TECHNICAL MEMORANDUM

Project: Stoney Wood Quarter, Mill Hill, London
Subject: Response to LBB Environmental Health and Planning Comments
To: Alex Kuropatwa
Written By: Jacob Tyler-White MIOA **Checked By:** Oliver Packman MIOA
Memo Ref.: 28113.TM.01 RevA **Date:** 15 May 2026

Figure 28113.TH1

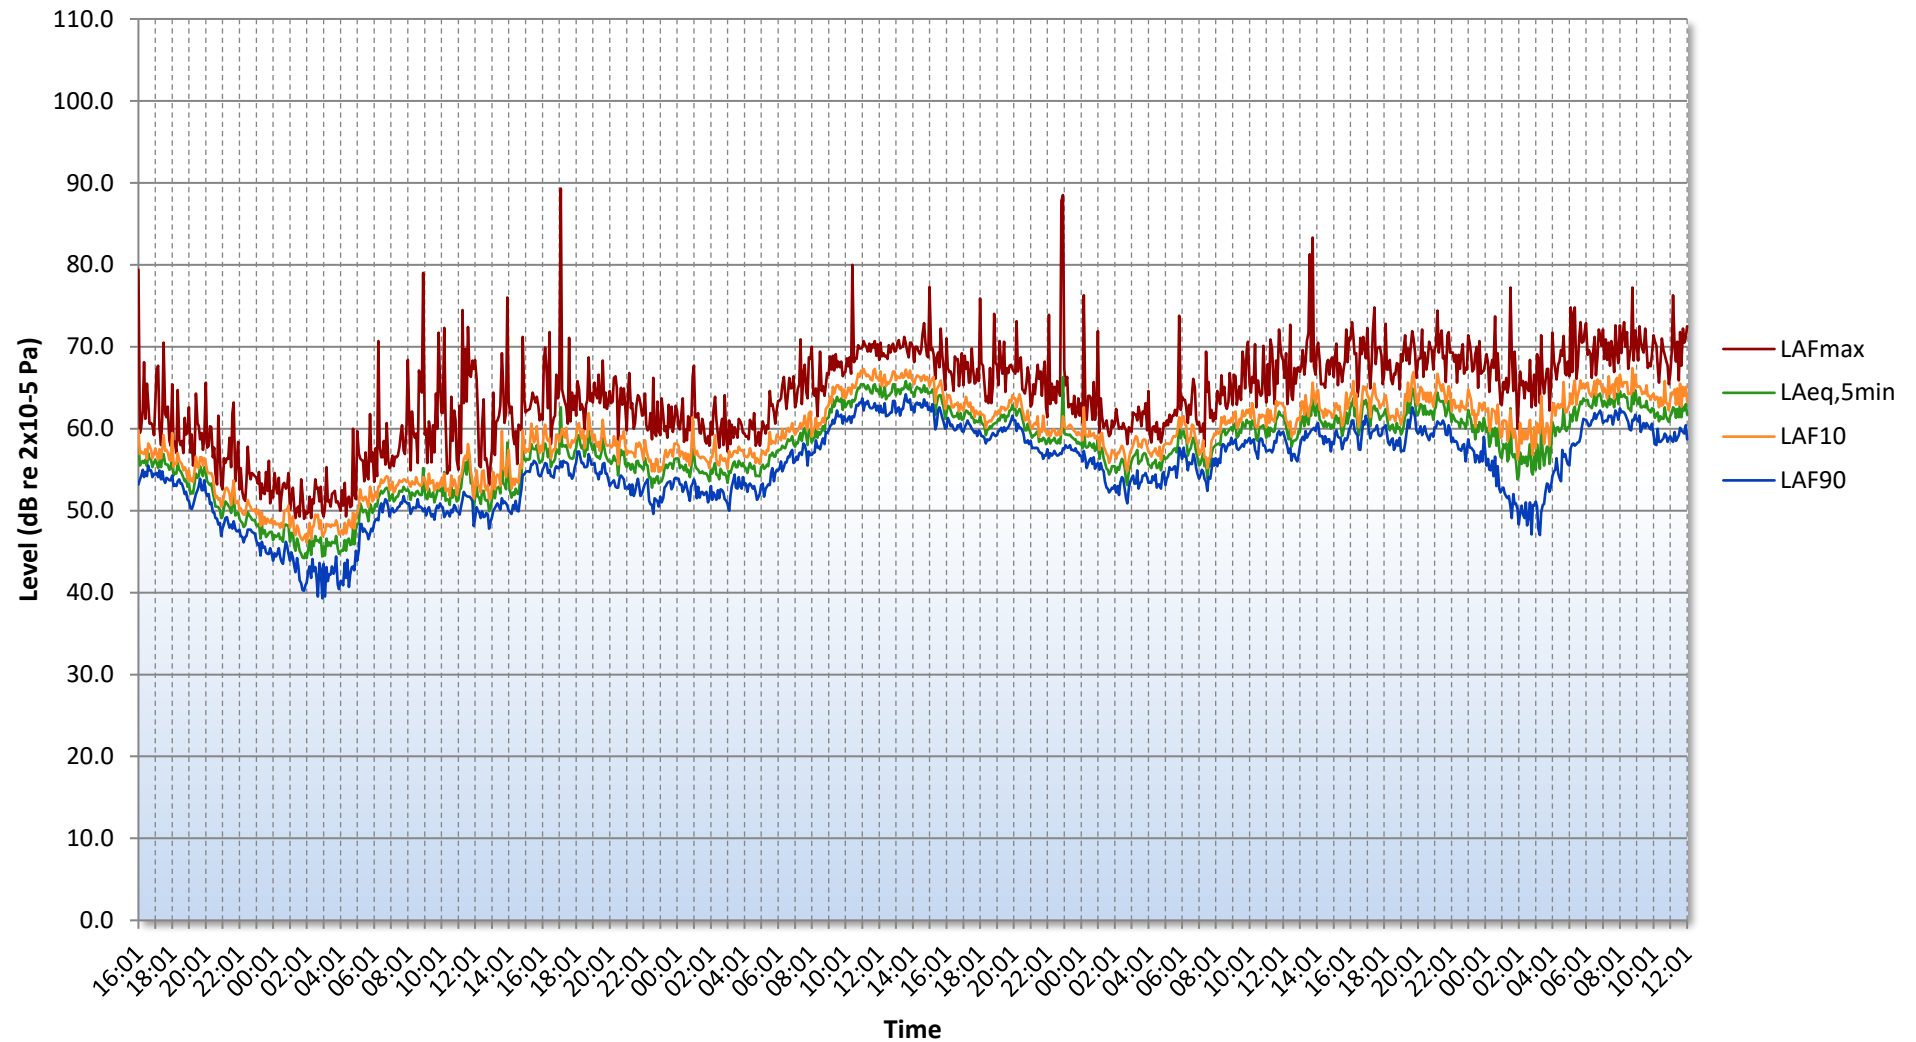
“Having reviewed the submitted documents, I am not satisfied with the noise survey data from Location-A (described as being at the nearest position to the M1) where only a single short term attended measurement was taken on 16/11/2024 between 11:45-12:00am (15 minutes duration).”

Full time-history data showing maximum noise levels (L_{AFmax}), ambient noise levels ($L_{Aeq,T}$) and background noise levels (L_{AF90}) are enclosed within Appendix TH1 and TH2. The attended

The long-term unattended measurements allow the attended measurement at Position A to be calibrated against concurrent measurements at Position 1, enabling representative daytime and night-time noise levels to be derived over the full survey duration. This approach is consistent with the representative measurement principles contained within ISO 1996-2:2017, particularly in situations where site access or security constraints prevent unattended monitoring at the closest façade location.
